REV C 15 Jan 2021 GM/G  
 Planning Application further revised, see notes above  
 REV B 10 Aug 2020 GM/G  
 Revised Planning Application marked at Revision B  
 REV A 05 Dec 2019 GM/G  
 Original Planning Application marked at Revision A

PROJECT  
**The Hoo: Scheme 2**  
**17 Lyndhurst Gardens,**  
**Hampstead, London**  
 Returning a Grand Victorian House to Private Domestic Accommodation NW3 SNU

DRAWING  
**Lower Ground Floor Layout**  
**as Proposed**

JOB No	DRAWING No	REVISION
19013	1120	C
STATUS FOR PLANNING

DRAWING  
**First Floor Layout**  
 as Proposed

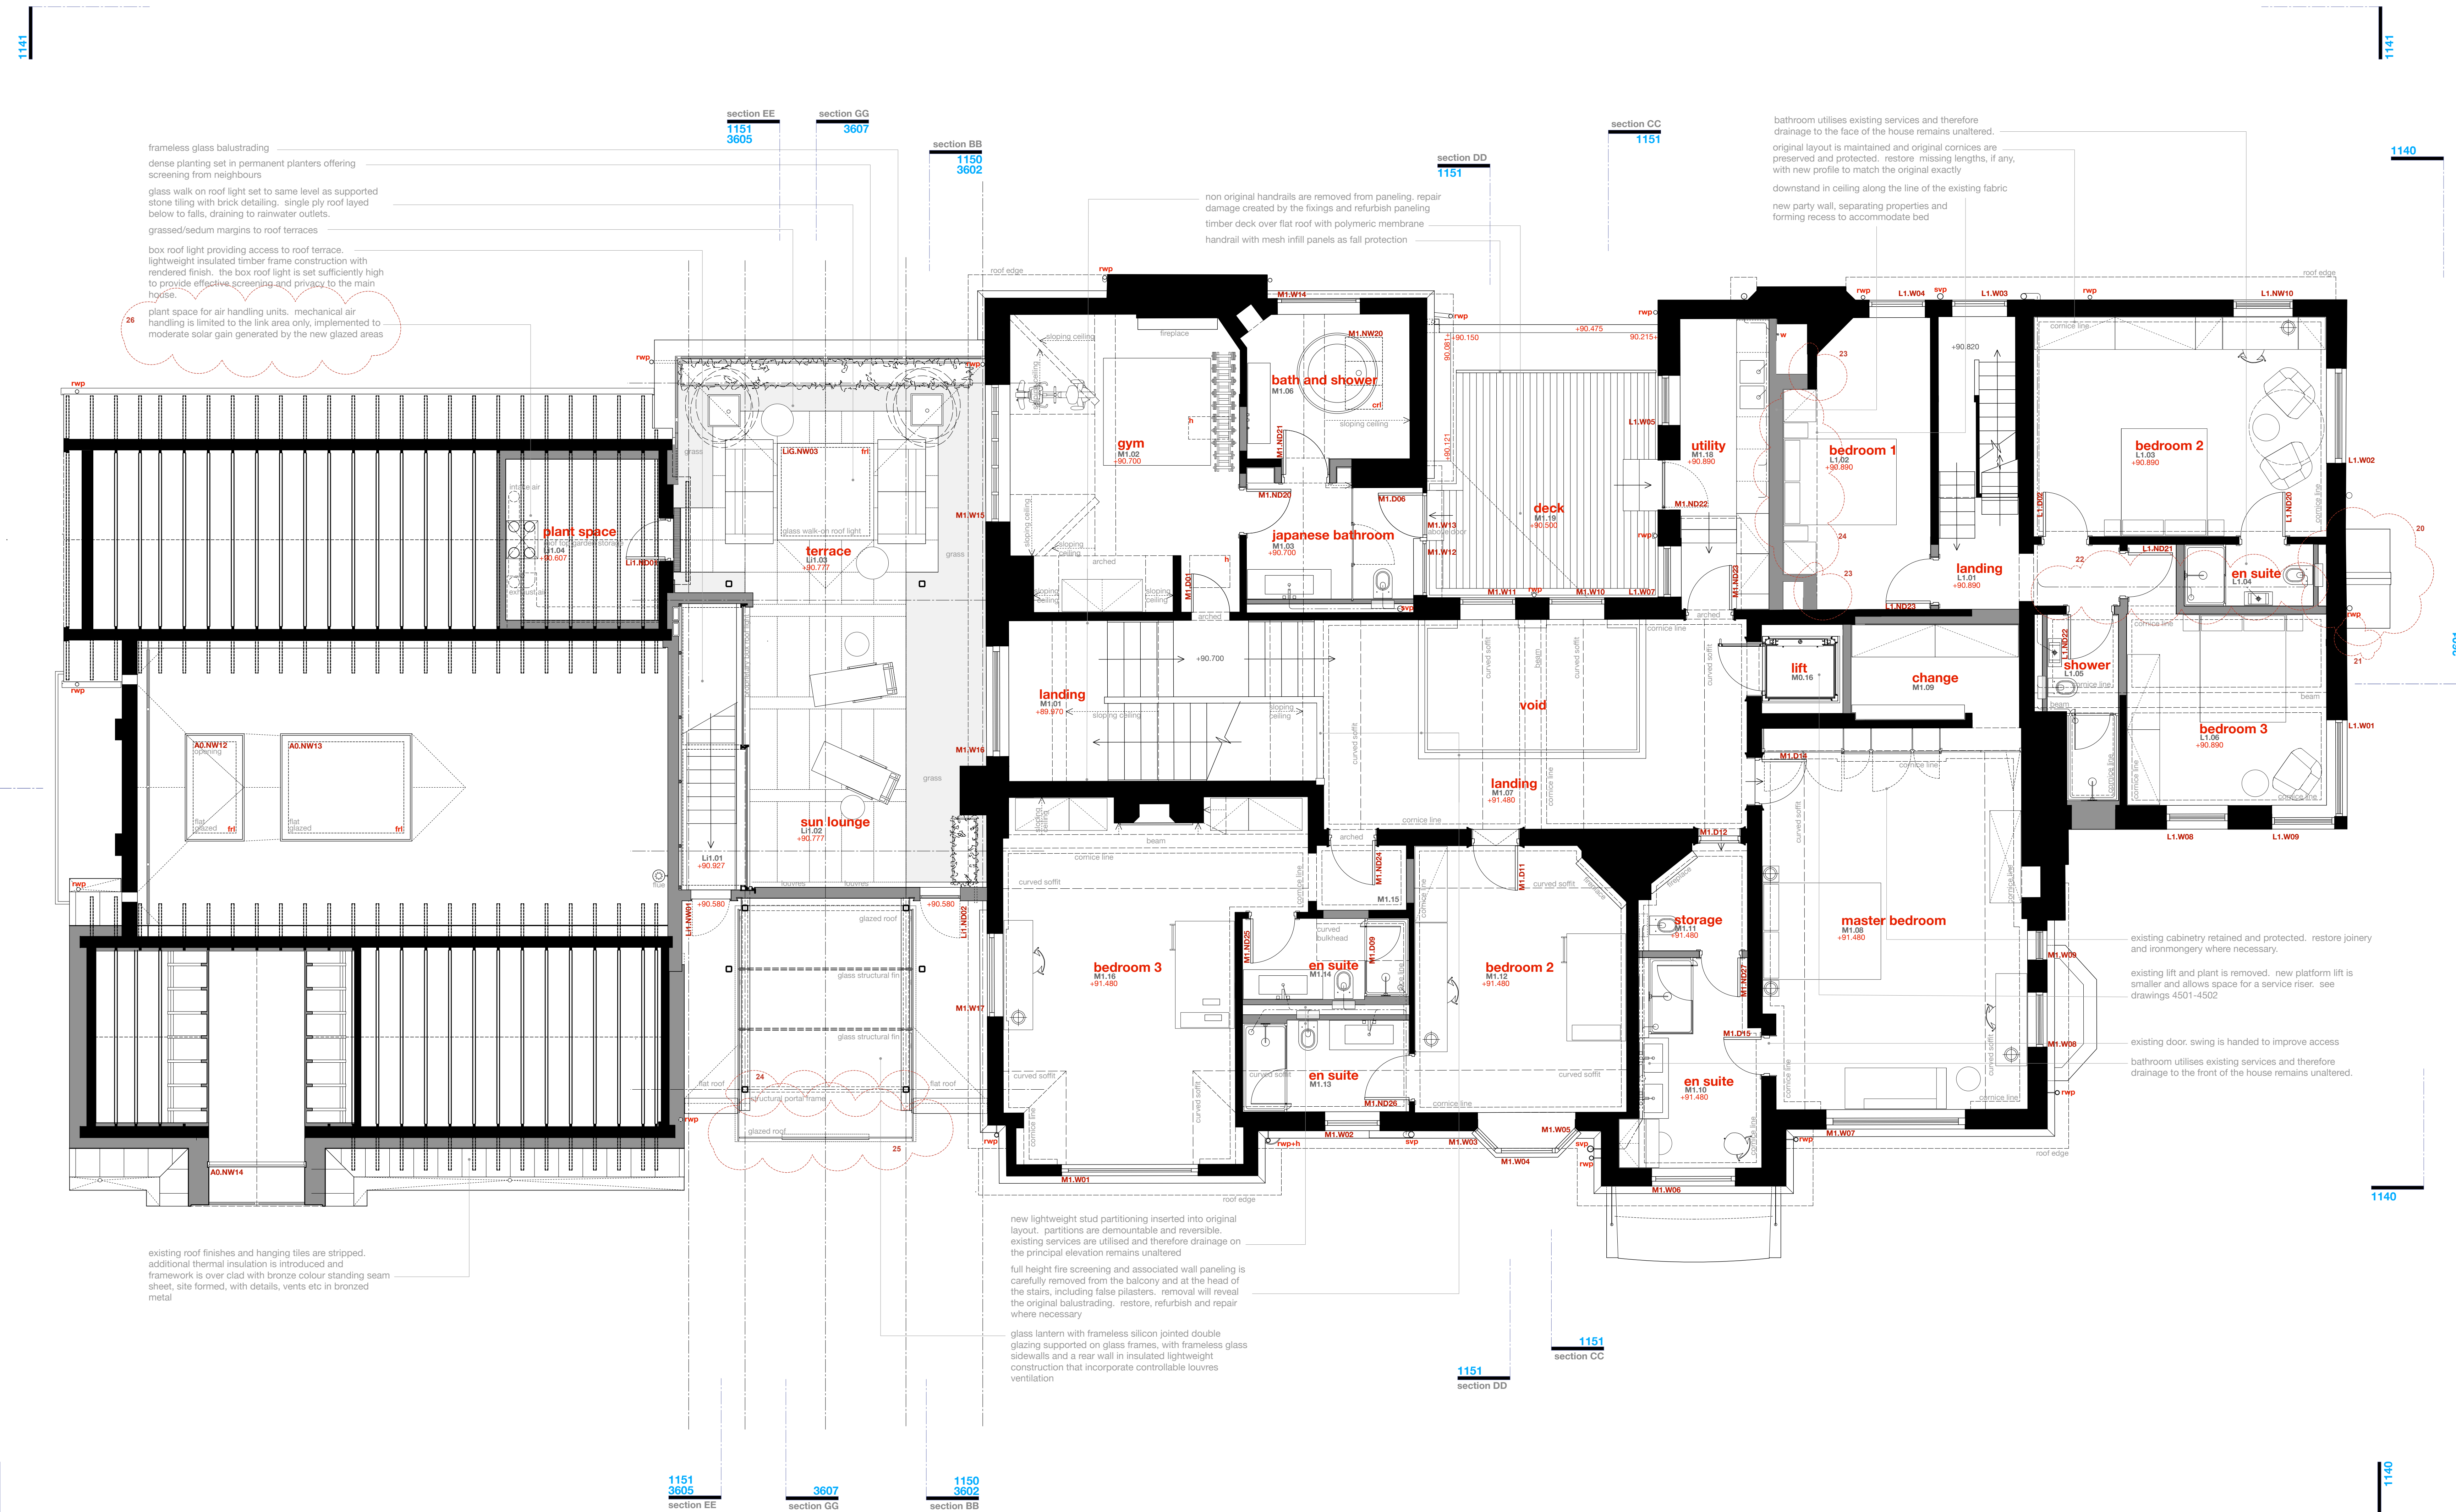
- scheme 2 further revisions**
- 20 proposed porch removed and existing canopy is retained.
  - 21 non original esp removed from principal facade, drainage is routed to north elevation
  - 22 revised drainage layout allowing non original esp to be removed from the principal east elevation
  - 23 length of ribs are increased and soffits is lowered, thus retaining more original fabric
  - 24 glt line and structure moved slightly northwards
  - 25 depth of glass bay reduced by 250mm to recess the proposed facade from principal facade of historic building
  - 26 test added and note more clearly defined

**DRAWING**  
**Second Floor Layout**  
**as Proposed**

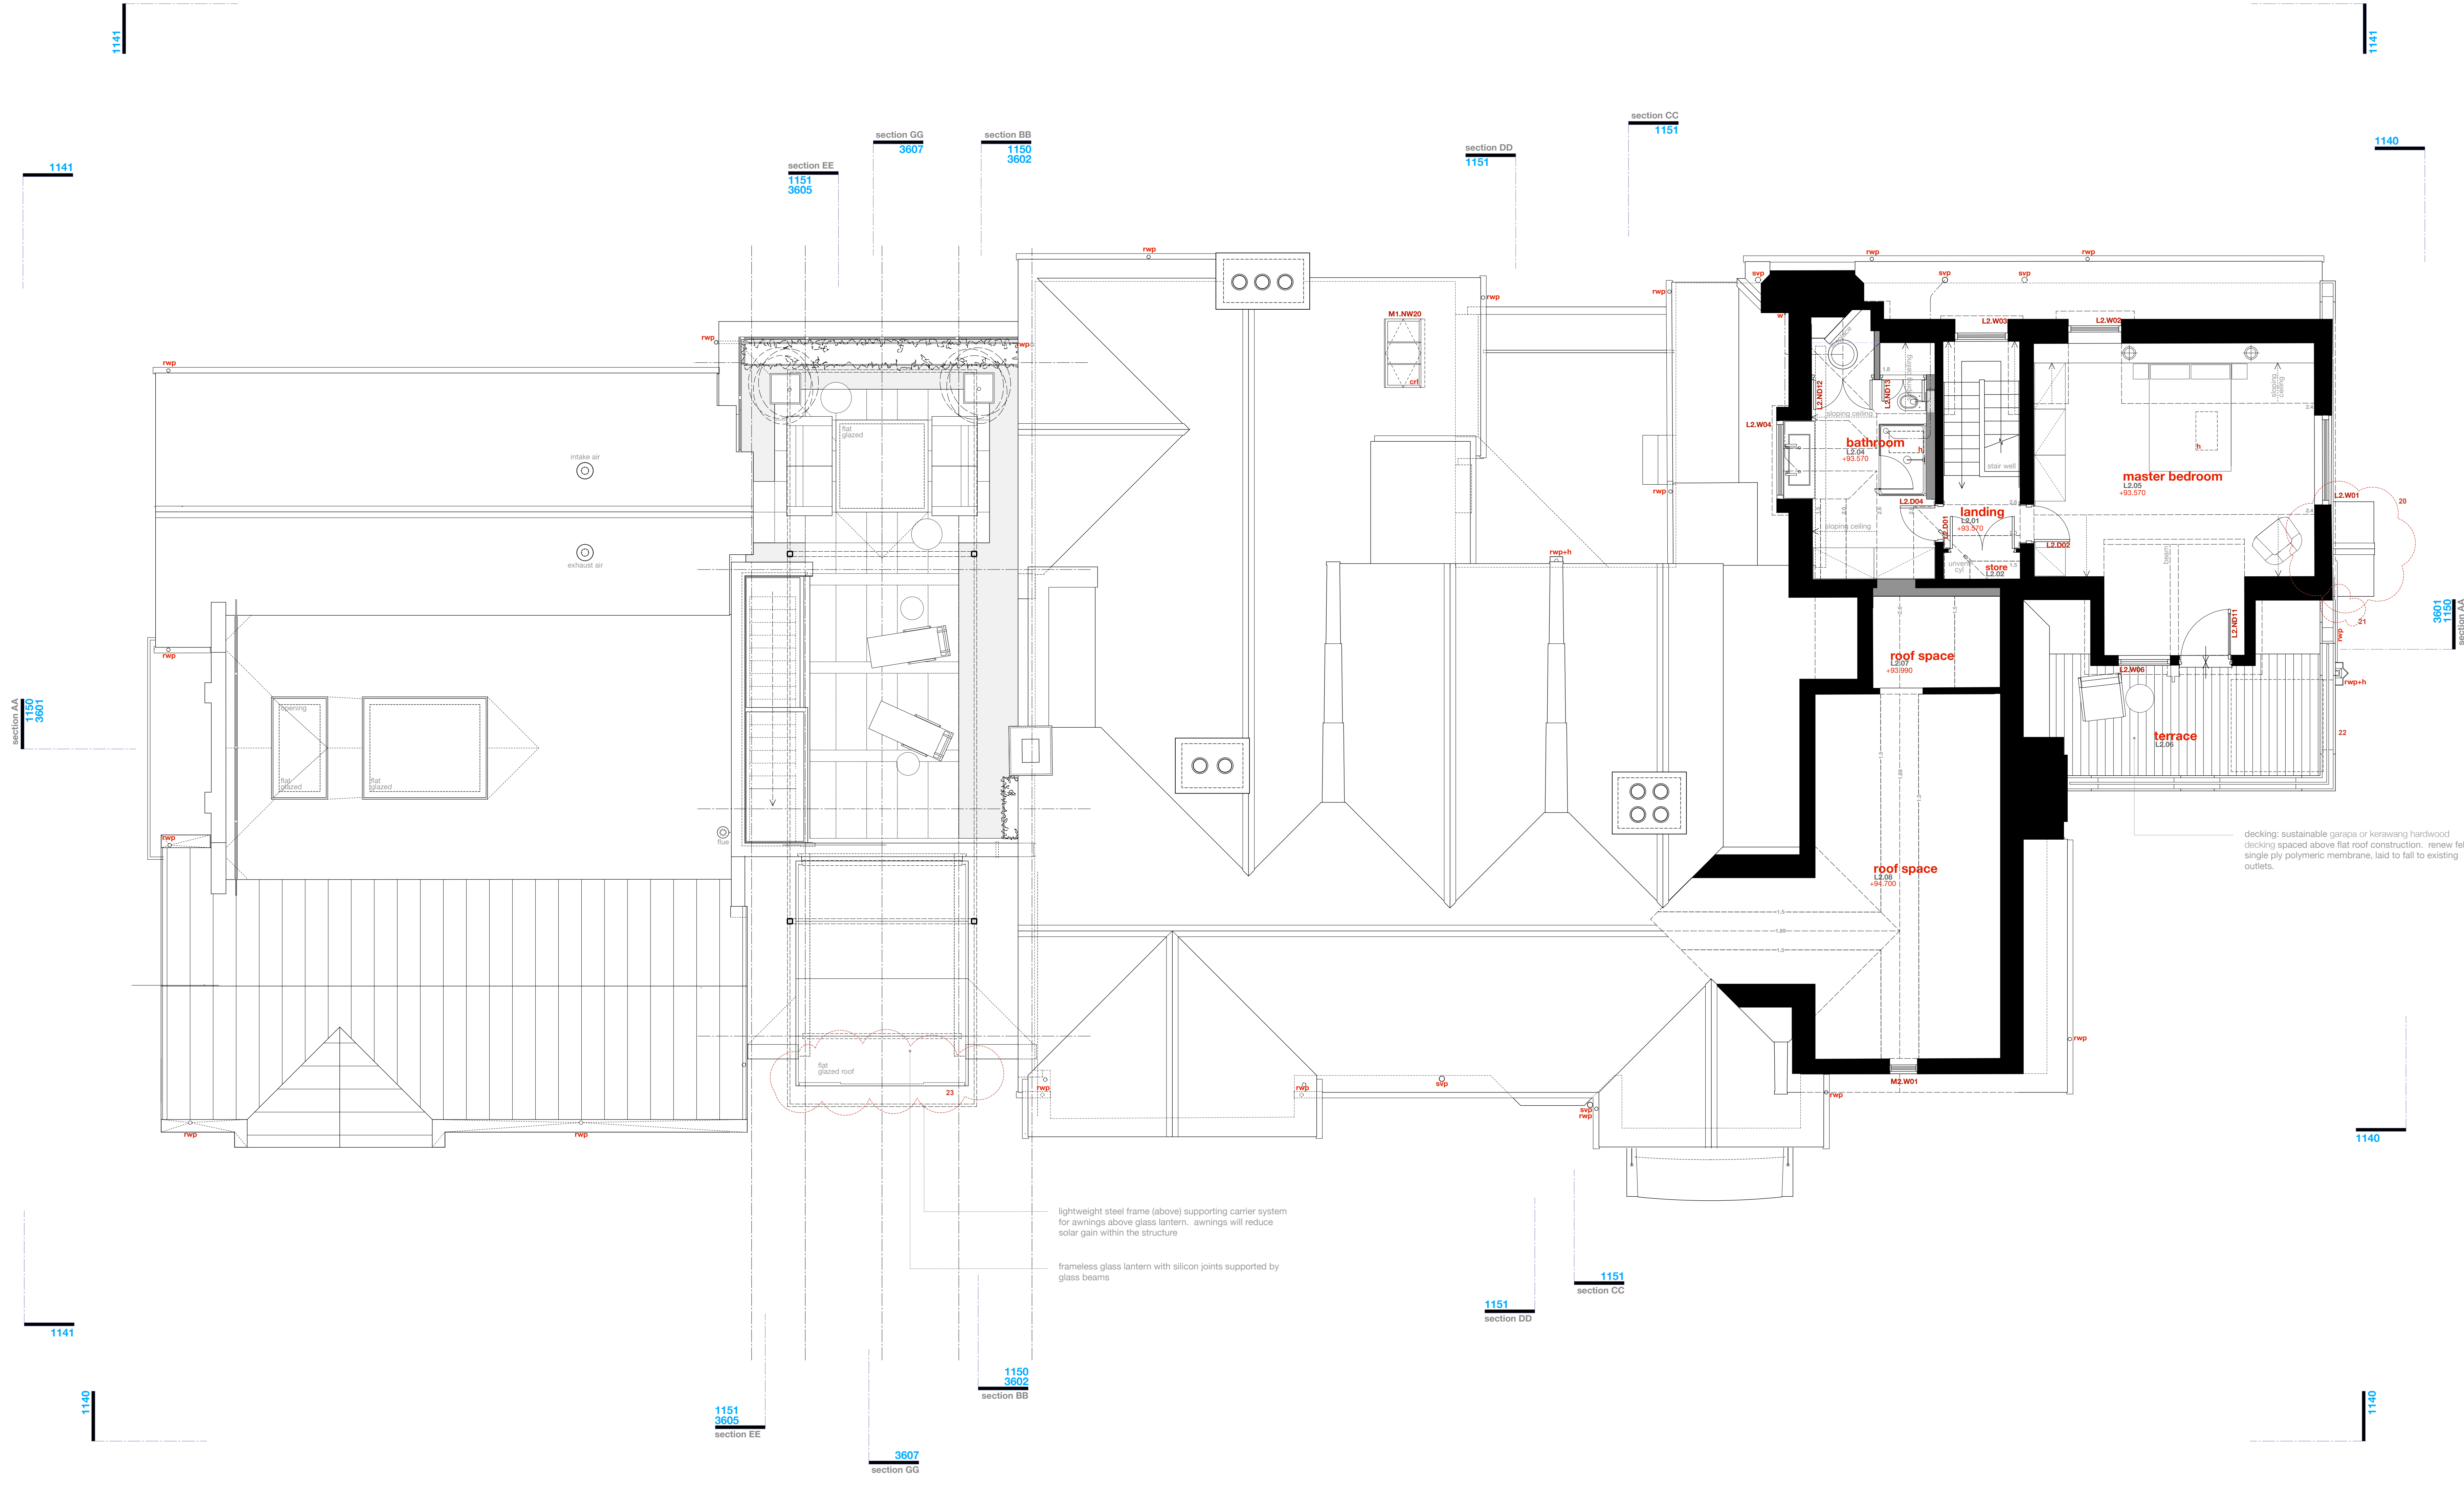
- 20 proposed porch removed and existing canopy is retained.
- 21 non original ssp removed from principal facade, drainage removed to north elevation
- 22 please note that the glass glazing full protection to the terrace L2.05 was removed on the previously revised drawings REV B and replaced with conventional perforated metal louvers, based on the existing design, with vertical bar infill.
- 23 depth of glass bay reduced by 250mm to recess the proposed facade from principal facade of historic building

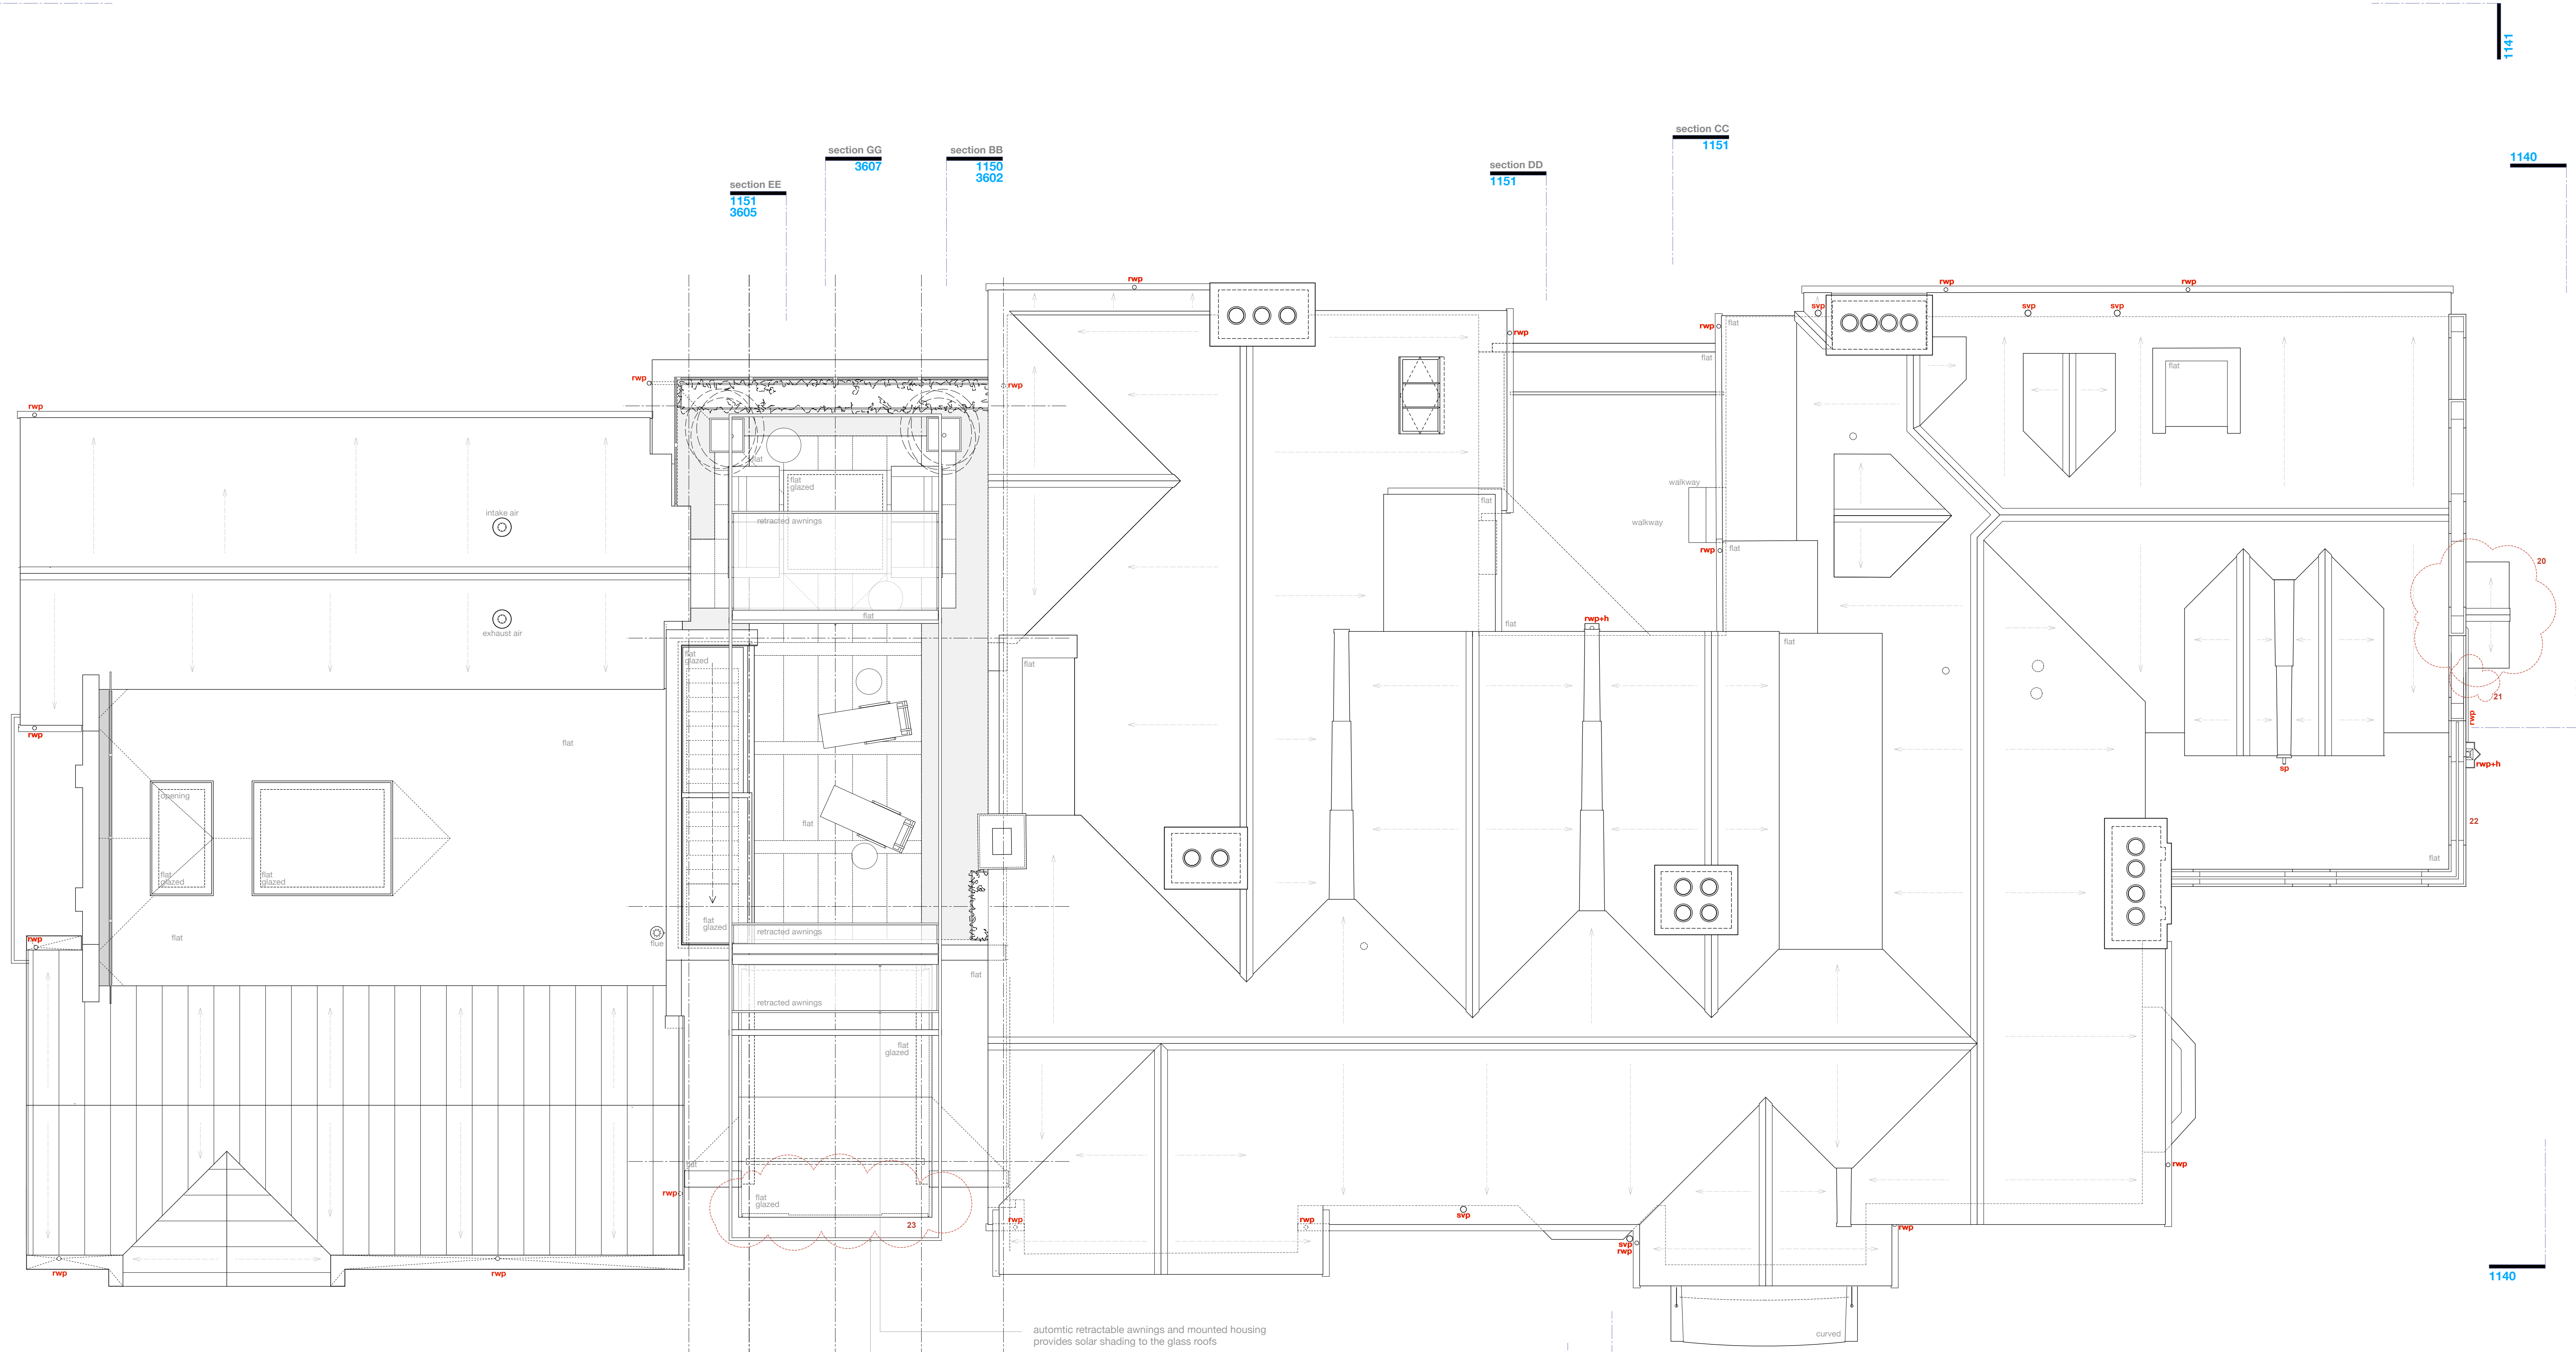
**scheme 2 further revisions**  
 20 proposed porch removed and existing canopy is retained.  
 21 non original ssp removed from principal facade, drainage re-routed to north elevation  
 22 please note that the glass guarding fall protection to the terrace L2.00 was removed in the previously issued drawing REV B, and replaced with conventional painted metal frames, based on the existing design, with vertical bar infill.  
 23 depth of glass bay reduced by 200mm to access the proposed facade from principal facade of historic building
